SUBJECT: DIABLO CANYON POWER PLANT, UNIT NO. 1 AND UNIT NO. 2 –
ISSUANCE OF AMENDMENT – REVISION OF TECHNICAL SPECIFICATION
(TS) TABLE 3.3.1-1, "REACTOR TRIP SYSTEM INSTRUMENTATION," AND
REVISED REACTOR COOLANT SYSTEM FLOW MEASUREMENT (TAC NOS.
MB6760 AND MB6761)

Amendment No. 161
License No. DPR-80

Amendment No. 162
License No. DPR-82

SAFETY EVALUATION BY THE OFFICE OF NUCLEAR REACTOR REGULATION
RELATED TO AMENDMENT NO. 161 TO FACILITY OPERATING LICENSE NO. DPR-80
AND AMENDMENT NO. 162 TO FACILITY OPERATING LICENSE NO. DPR-82
PACIFIC GAS AND ELECTRIC COMPANY
DIABLO CANYON POWER PLANT, UNITS 1 AND 2
DOCKET NOS. 50-275 AND 50-323

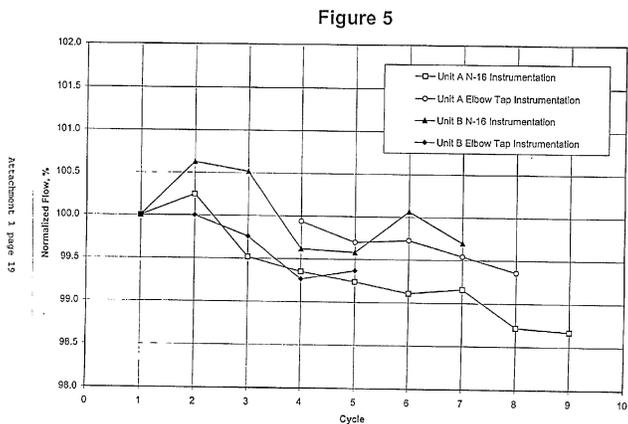
Significant experience is also available that supports a conclusion that elbow tap flow meters are stable during long-term operation. For example, Section 4.1.4 of WCAP-15113 (Reference 15) discusses an evaluation of comparisons between RCS flow measurement data using elbow taps and ultrasonic leading edge flow meters (LEFM) from the Hydraulic Test Program at Prairie Island Unit 2. The comparisons were stated to cover 11 years of operation during which an RCP impeller was replaced and included cases of both one and two RCPs operating. The data showed that the average flow rate difference between the elbow tap and the LEFM flow measurements was less than 0.3 percent. Another comparison performed before and after RCP replacement showed that the LEFM and elbow tap measurements agreed to within an average of 0.2 percent on the ratio of flows when one and two pumps were operating. WCAP-15113 and WCAP-14754-NP-A (Reference 16) provided the following data to substantiate these conclusions:

The staff notes that, although the Prairie Island tests covered 11 years of operation, data were obtained sporadically and recalibrations may have been involved.

The reproduced Figure 6, to the right, provides a similar comparison of N-16 and elbow tap flow rates for a third plant. Again, the elbow tap data appear somewhat more stable than the N-16 indications, but overall there is little variation.

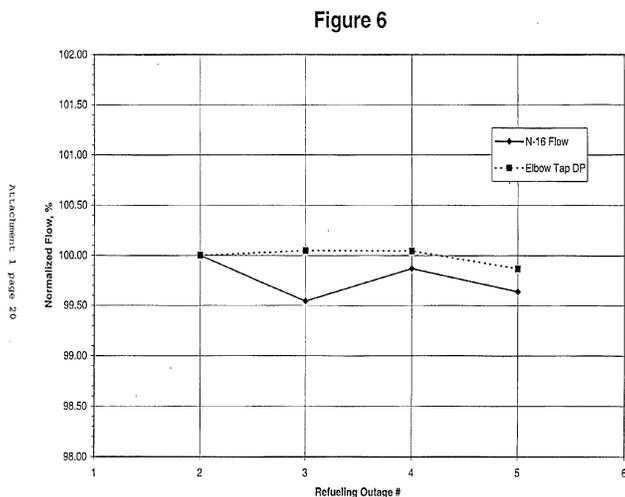
There is no evidence of a long-term change in the elbow tap indications in comparison to the N-16 indications and the data generally substantiate that the elbow tap flow coefficients remain constant with increasing time.

Based on the above evaluation, the staff finds that the elbow tap flow meter coefficients remain sufficiently constant that the relative changes of flow rate through the cold-leg elbows can be correlated with the relative changes in the elbow tap ΔP s.

The RCS configuration illustrated in Figure 1 is used as a basis for flow rate analyses. An overall heat balance is taken over the control volume defined by the surface of the RCS to obtain Equation 7:

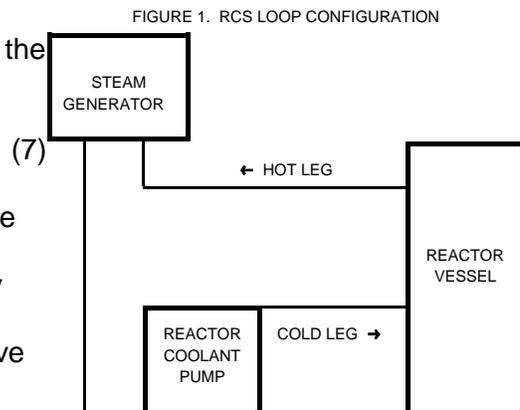
- where:
- Q_{core} = nuclear heat generation rate in the core,
 - Q_{RCP} = rate of energy addition to RCS by RCPs,
 - Q_{loss} = net rate of RCS heat loss exclusive of SGs and RCPs,
 - Q_{cal} = rate of heat removal by SGs, and,

for now, no mass flow is assumed to pass through the RCS pressure boundary. This assumption is addressed in Section 3.3.4 below.

Since Q_{cal} is determined from the calorimetric, and Q_{loss} and Q_{RCP} can be estimated, this equation will provide Q_{core} .
